Clarification 3

16 March 2009

**Support & Maintenance of the
Government Network of Maldives**

Clarifications

Figure 1: Diagrammatic representation of the core equipment showing redundant connectivity. The connection configurations are subject to changes.

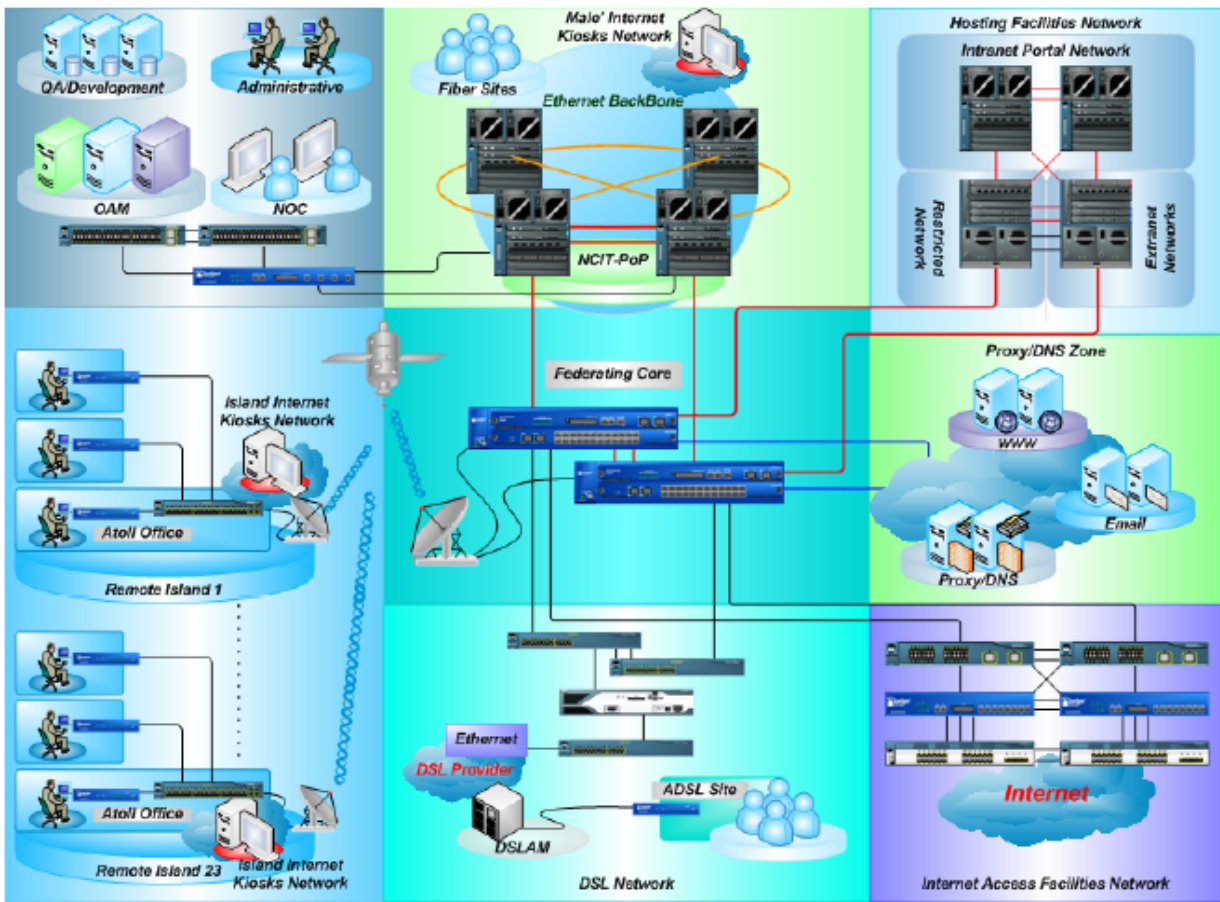
Question 2: Redundant connectivity of core equipment.

Answer to Question 2: Reference is made to clarification document 2 questions 10 and 17. Please see attachment 1 for a revised network core diagram.
